APPLICATION NO.	FILING DATE	FIRST NAMED INVENTOR	ATTORNEY DOCKET NO.	CONFIRMATION NO.
09/740,902	12/21/2000	Junichi Asada	201163US2S	6347

Office Action Summary	Application No. 09/740,902	Applicant(s) ASADA, JUNICHI	
	Examiner Chris C. Chu	Art Unit 2815

DETAILED ACTION

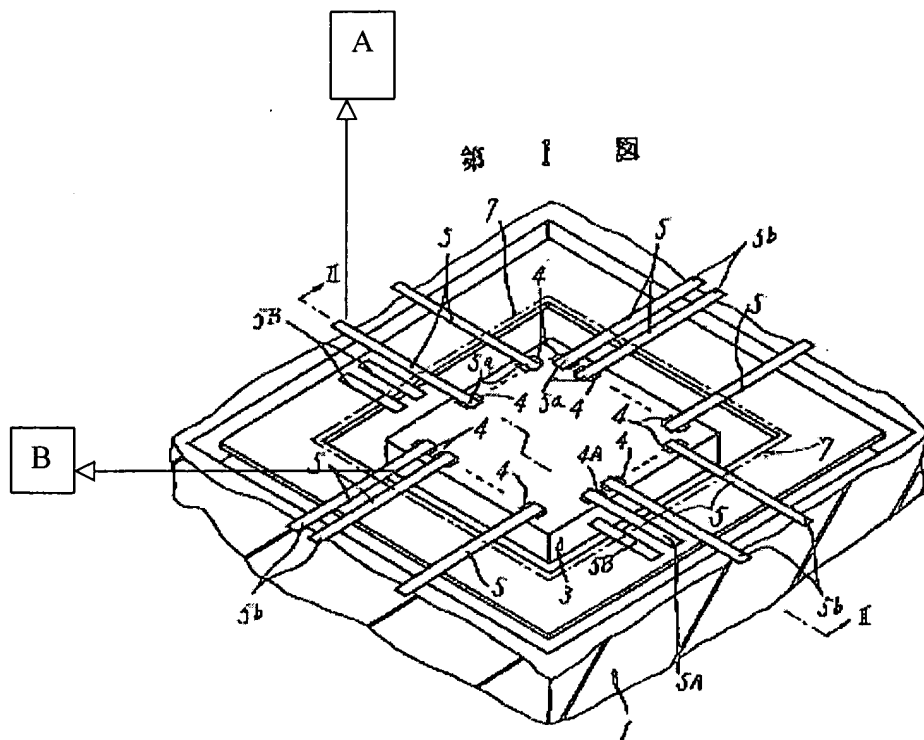
Oshino et al. does not disclose tip portions of the dummy lead wires positioned to face each other being connected to each other to form a straight dummy lead wire.

However, Candelore discloses in Fig. 4 tip portions of lead dummy wires (420 and 430) positioned to face each other being connected to each other to form a straight dummy lead wire (421). Thus, it would have been obvious to one of ordinary skill in the art at the time when the invention was made to modify Oshino et al. by connecting the two dummy lead wires as taught by Candelore. The ordinary artisan would have been motivated to modify Oshino et al. in the manner described above for at least the purpose of deterring to probe of the micro-electronic component (column 3, lines 51 and 52).
